APPENDIX A – LIST OF REFERENCES

APPENDIX B – LIST OF EXHIBITS

Re: COMMENTS, RECOMMENDATIONS, TERMS AND CONDITIONS
Dead River Hydroelectric Project (FERC Project No. 10855)
Upper Peninsula Power Company, License Application

Figure 8 - Fuse plug embankment and pilot channel cross sections.

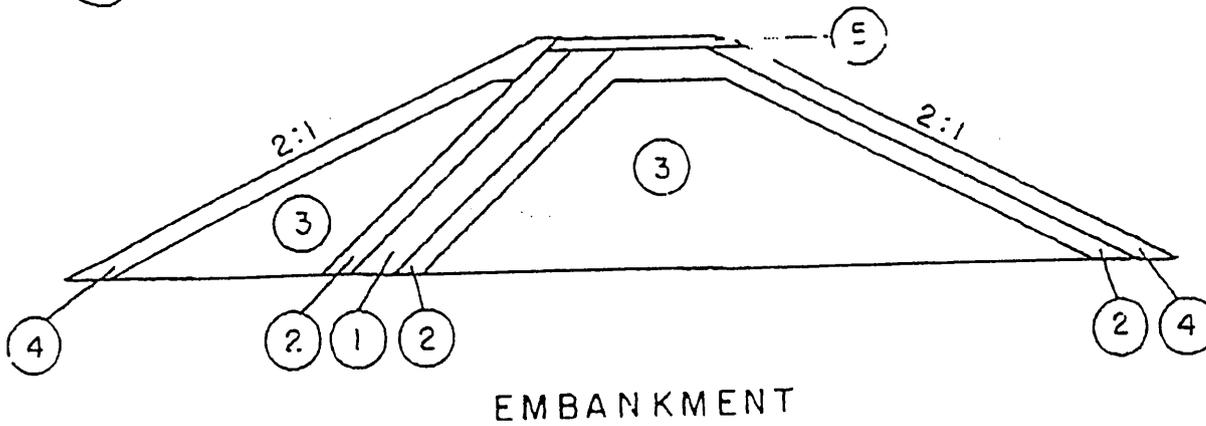
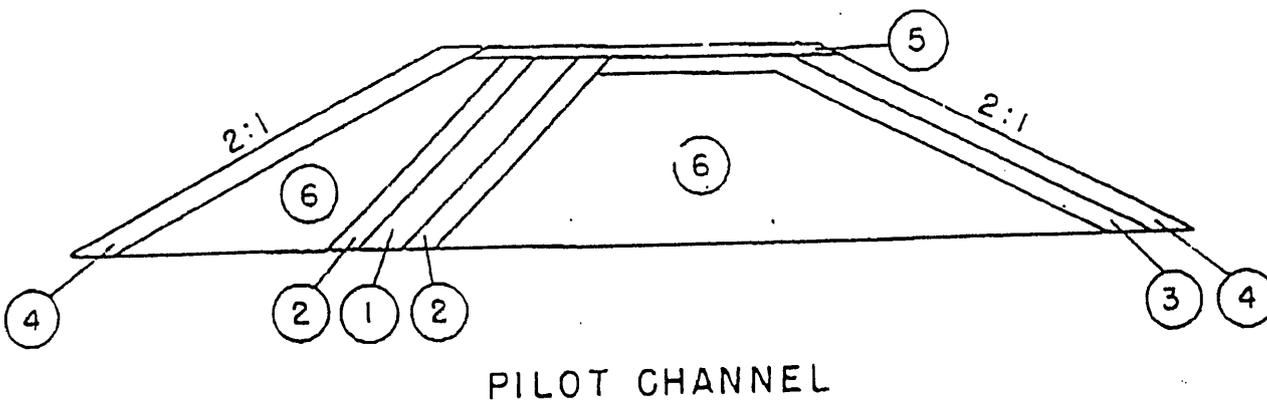
2. Drawing 18305G-03 provides a cross section of a typical proposed fuse plug section. A typical pilot channel cross section is also needed. Attachment 1 shows typical cross sections of a fuse plug and a pilot channel from page 17 of the Bureau of Reclamation publication REC-ERC-85-7. The materials in the fuse plug and pilot channel cross sections are not the same, ie Type 6 material in the pilot channel section replaces Type 3 material in the fuse plug embankment and Type 3 material in the pilot channel section replaces the downstream Type 2 material in the fuse plug embankment.

Figure 9. - Prototype gradation curves.

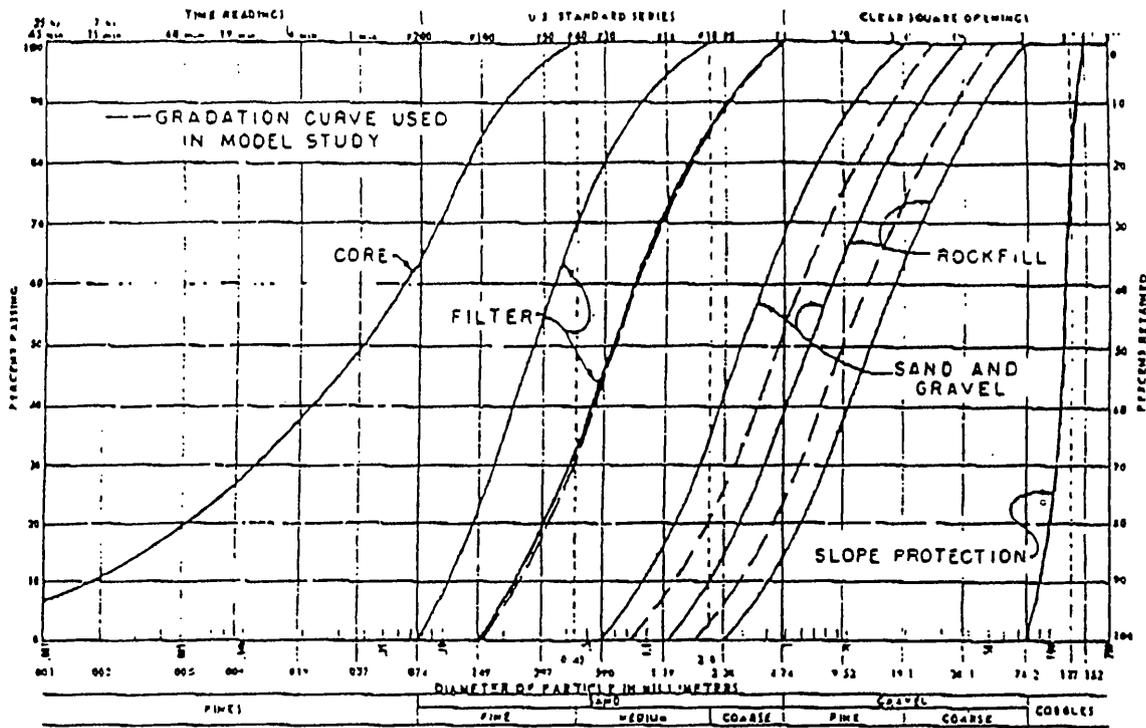
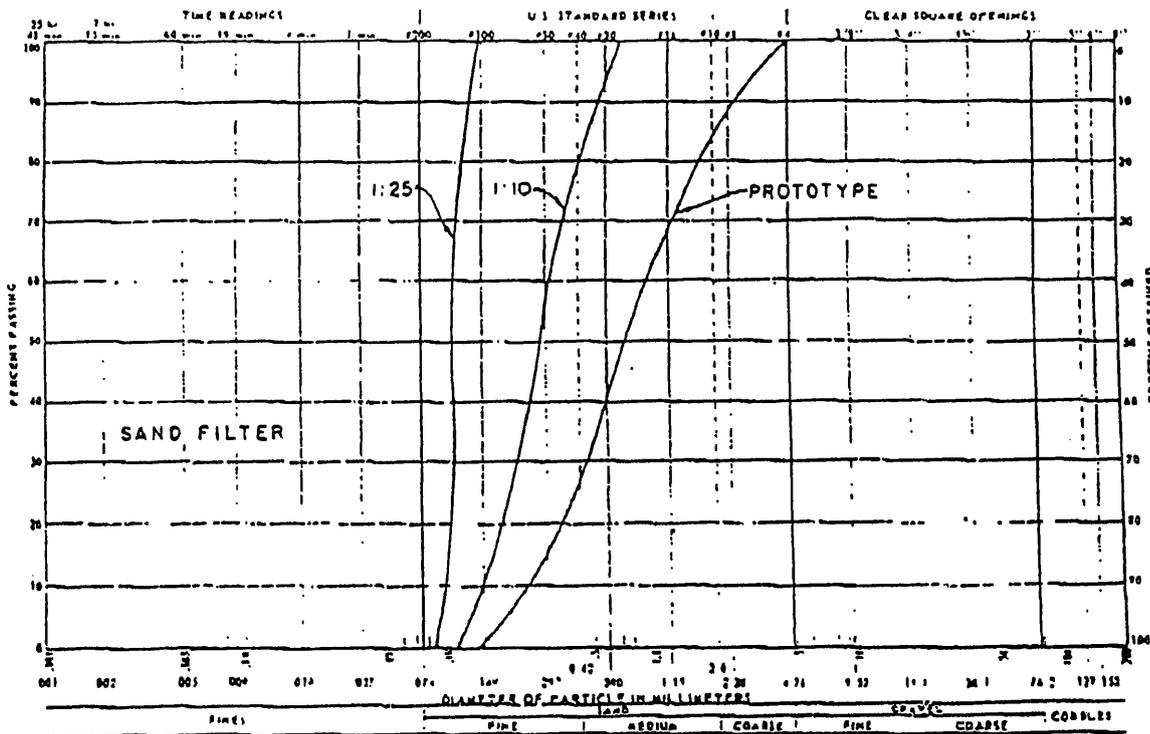
a. Type 1 material, Silty Sand Core, should show approximately 100% passing the #40 sieve and 63% passing the #200 sieve.

b. Type 3 material, Riprap Slope Protection, should show approximately 100% passing the 6 inch sieve, 70% passing the 5 inch sieve, and 0% passing the 3 inch sieve.
